R.E. Ginna Nuclear Power Plant

Subject: License Amendment Request Regarding Adoption of Relaxed Axial Offset
Control (RAOC)
R.E. Ginna Nuclear Power Plant
Docket No. 50-244

Enclosures: 1. Evaluation of Proposed Change
 2. Proposed Technical Specification Changes (markup)
 3. Revised Technical Specification Pages (retyped)
 4. Marked-up Copy of Technical Specification Bases
 5. List of Regulatory Commitments

Figure B 3.2.1B-1 (page 1 of 1)
K(Z) - Normalized F₀(Z) as a Function of Core Height

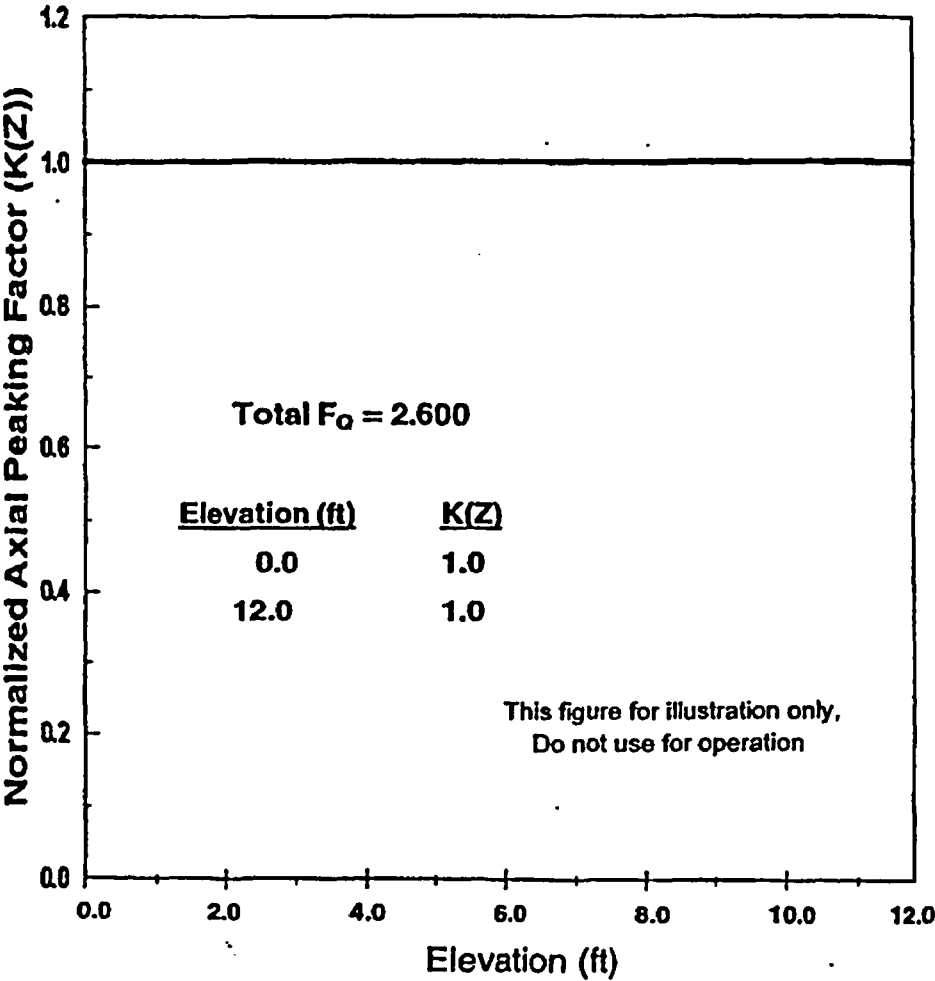
For this facility, the actual values of CFQ and $K(Z)$ are given in the COLR; however, CFQ is normally a number on the order of ~~2.32~~ ^{2.60} and $K(Z)$ is a function that looks like the one provided in Figure B 3.2.1B-1.

Figure B 3.2.3B-1 (page 1 of 1)
AXIAL FLUX DIFFERENCE Acceptable Operation Limits
as a Function of RATED THERMAL POWER

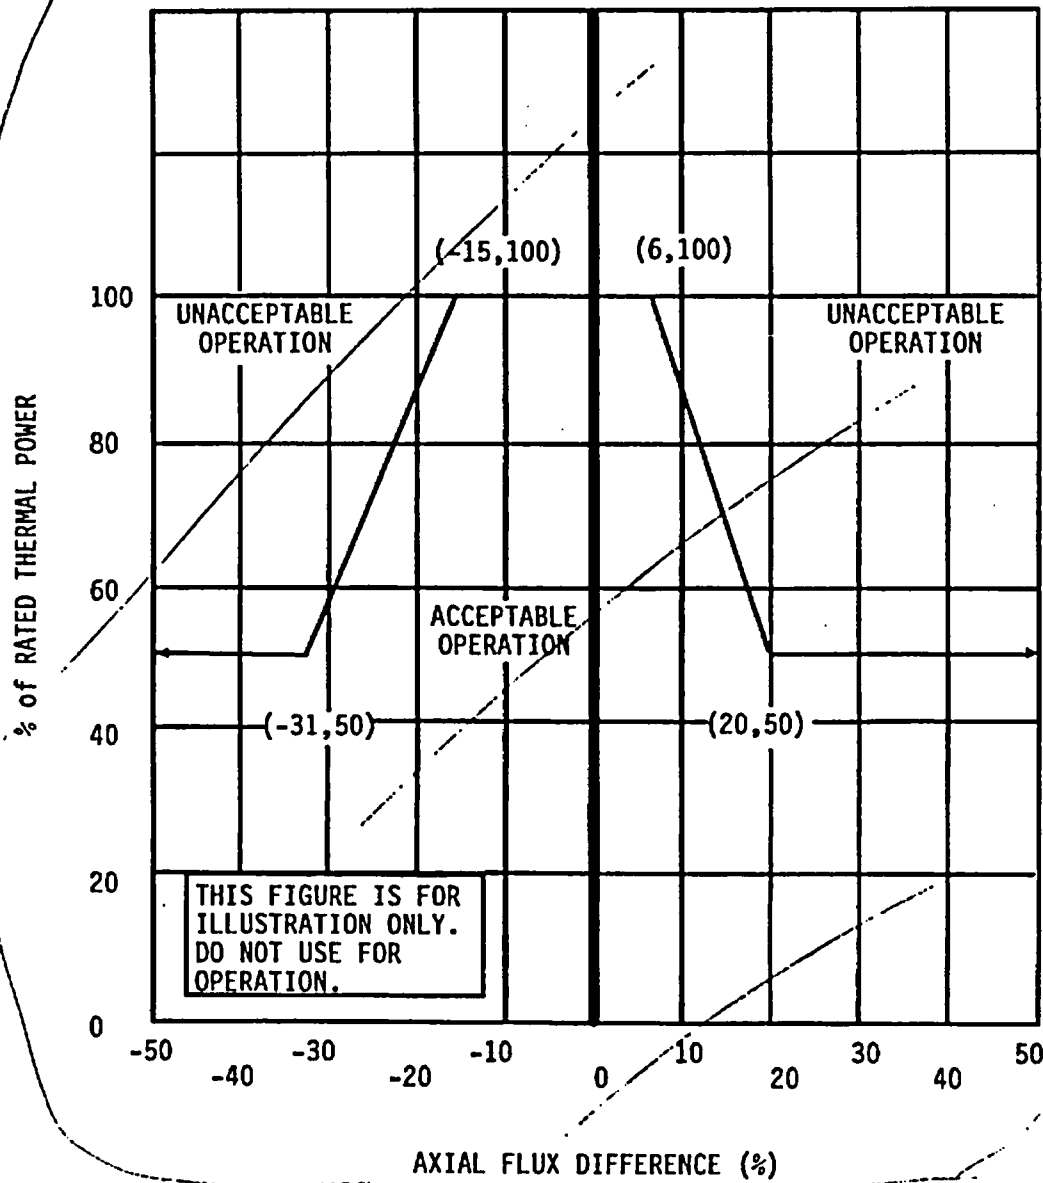
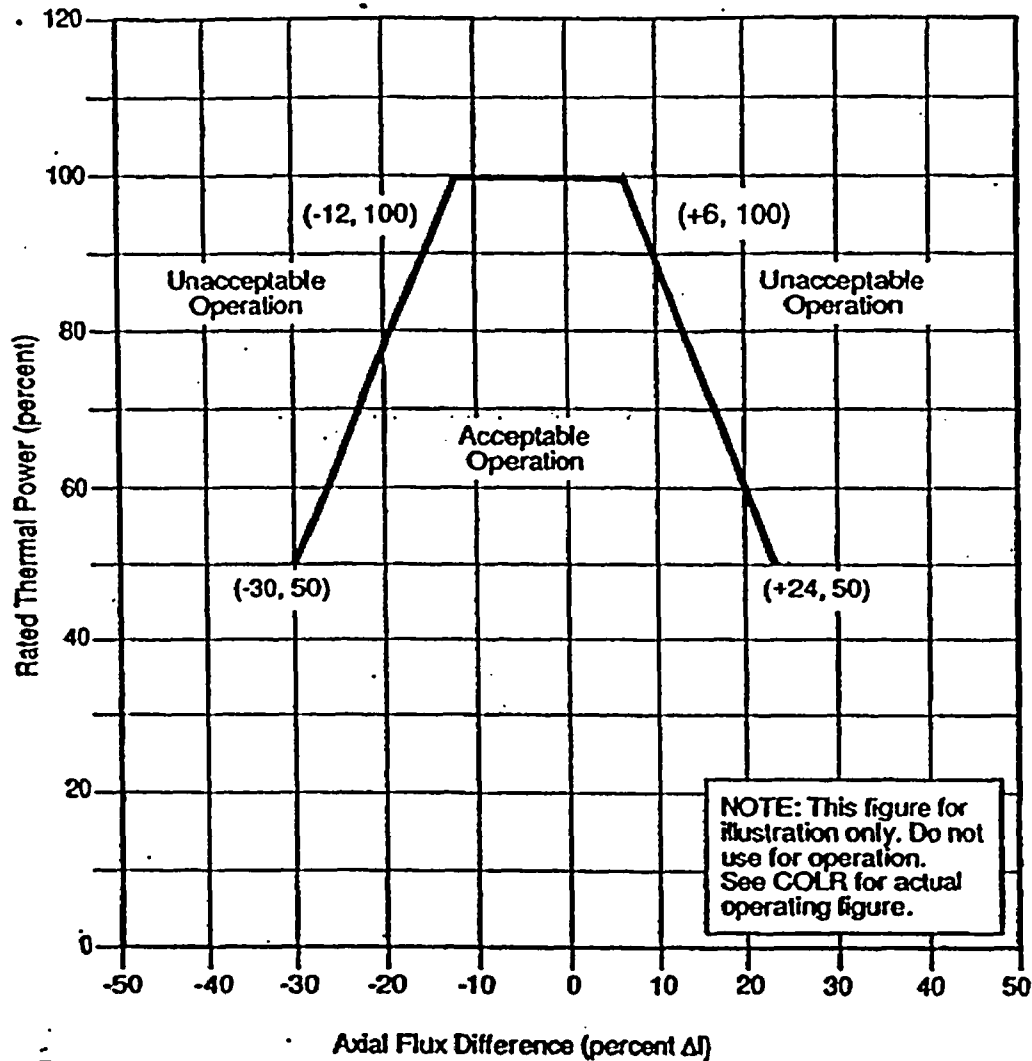
The AFD limits are provided in the COLR. Figure B 3.2.3B-1 shows typical RAOC AFD limits. The AFD limits for RAOC do not depend on the target flux difference. However, the target flux difference may be used to minimize changes in the axial power distribution.

Insert A page B3.2.3-4
